Our Case Number: ABP-316828-23

Re: Tallaght/Clondalkin to City Centre BusConnect Core Bus Corridor Scheme.
Tallaght/Clondalkin to Dublin City.

SUBMISSION RE TALLAGHT CLONDALKIN CORRIDOR REF 316828-23

Proposed CBC – Estimated change in road traffic with CBC in place (AM Peak 2028)

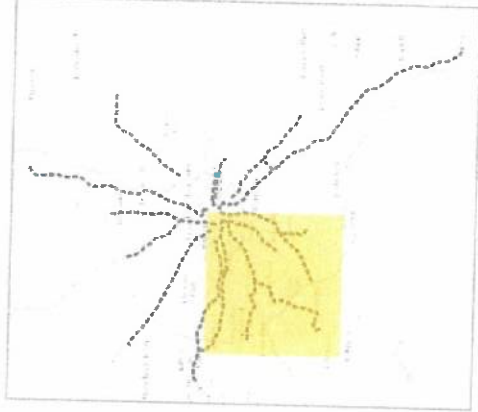
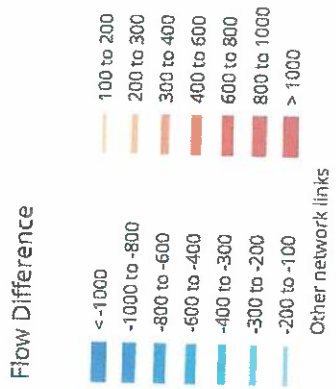
Draft projections showed an extraordinary amount of traffic on Downpatrick Road (see attached) a very narrow road off Sundrive Road. This has entirely disappeared in the final version, even though there appear to be no changes which should make the problem go away. This entirely undermines my belief in any of the figures.
